GILLIG CORPORATION

Safety Defect and Noncompliance Report Guide for Vehicles
PART 573 Defect and Noncompliance Report¹

Gillig Low Floor Bus Front Axle Rod Removal and Installation Procedures

Figure 1: Clamp Identification Aid

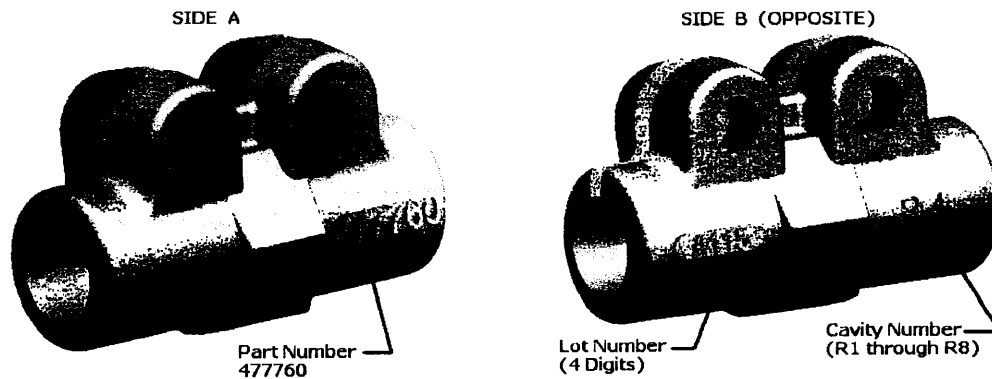
After the bus is put on a lift where the rods can be easily accessed and inspected, the suspect clamps can be identified as noted in the attached photo (Figure 1).

Figure 2: Identification Aid for Clamps Not Included in the Recall

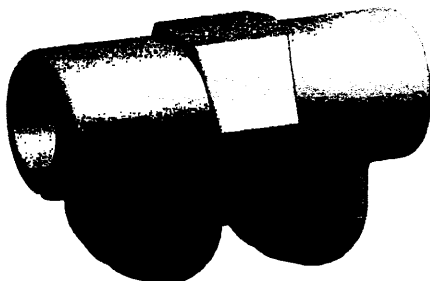
Not included in the recall are rods with clamps having the part number 477762 cast in them. These clamps can also be identified with a cavity number ending in the letter S and a 4 digit numerical lot number. Unlike the recalled clamps, these clamps will have all of the identification marking cast into the part on the same side. See Figure 2

Figure 3: Procedure to adjust new rod to length of removed rod.

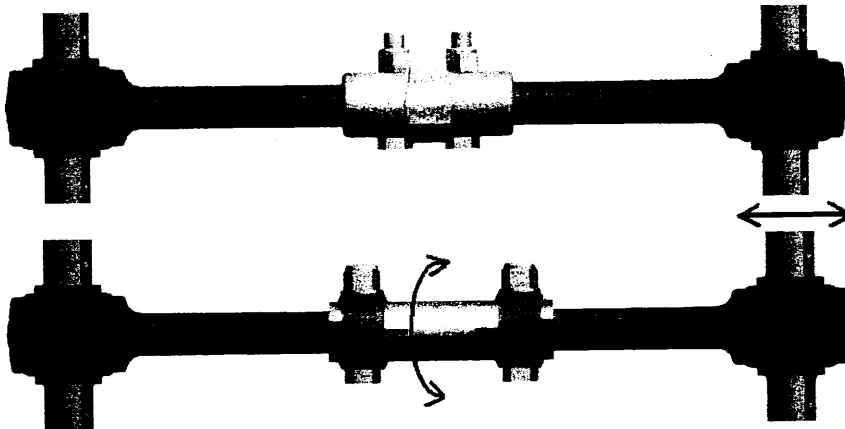
- Replacement rods will need to be adjusted to the same length as the rod it is replacing.
- Replacement rods clamps are tightened to a low torque for shipping. Loosen clamps before adjusting.
- Adjust the replacement rod by turning the clamp spacer, **not the rod ends**, until it is equal in length to the removed rod (See figure 3).

Note the new rod utilizes a clamp design with a machined center spacer with individual clamps on each end. Adjust the replacement rod to the same length as the removed rod by rotating the center spacer, not the rod ends. This procedure will assure that the bus alignment is maintained.
